Docket Item # 3
BAR CASE #2012-0204

BAR Meeting
July 11, 2012

ISSUE: Certificate of Appropriateness - Signage
APPLICANT: PNC Financial by M. Catherine Puskar
LOCATION: 825 North Washington Street
ZONE: CDX / Commercial Zone

SIDE VIEW (TYP) NTS

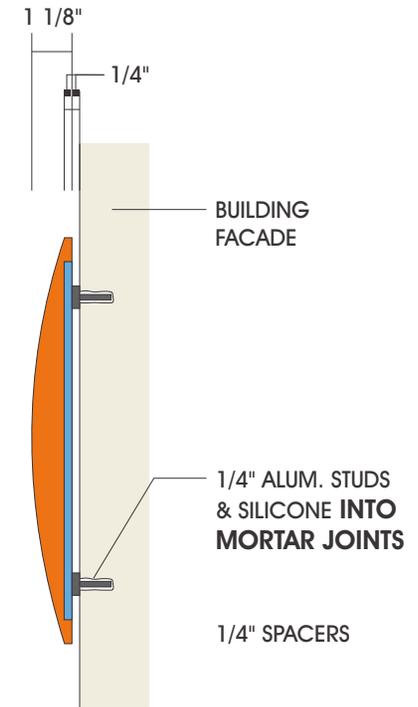
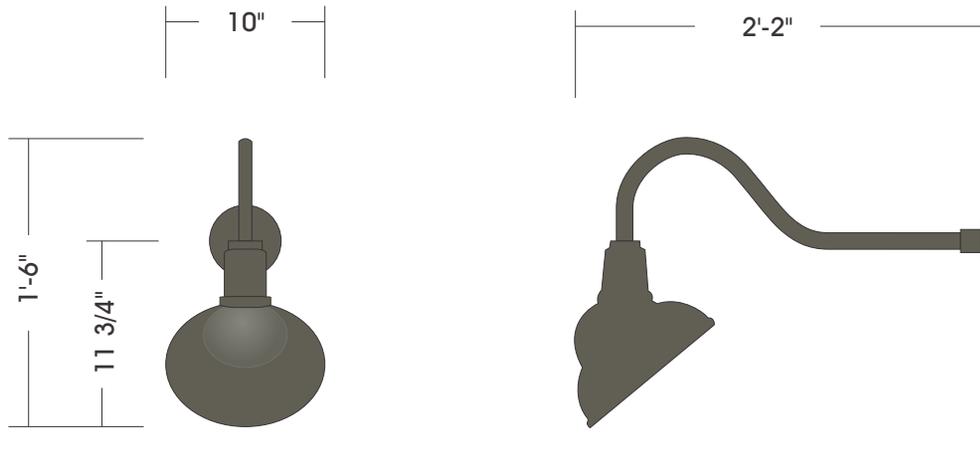
Staff recommends approval of the Certificate of Appropriateness application with the Board’s standard condition for all signage to be mounted on masonry buildings: That the sign be mounted on the building utilizing the existing mortar joints.

The concerns with this proposal are the same as previously mentioned for the Redpeg logo a block away. It is a concern that setting the logo on the side of the building, facing Washington Street, creates a billboard - far different from a sign by the door stating the business. This proposed sign is obviously meant to appeal to people in their cars instead of on foot. Obviously, in an area with at least three lighted gas station signs less than a block away, this may be a difficult argument for NPS to make. However, NPS would like to avoid going down the road of billboards on sides of buildings facing Washington Street. In addition, NPS felt the "goose-neck" lamps adds extra un-necessary infrastructure to the visual scene, even if the location on the building is altered.

Staff recommends approval of the Certificate of Appropriateness with the condition that the sign be mounted on the building utilizing the existing mortar joints.
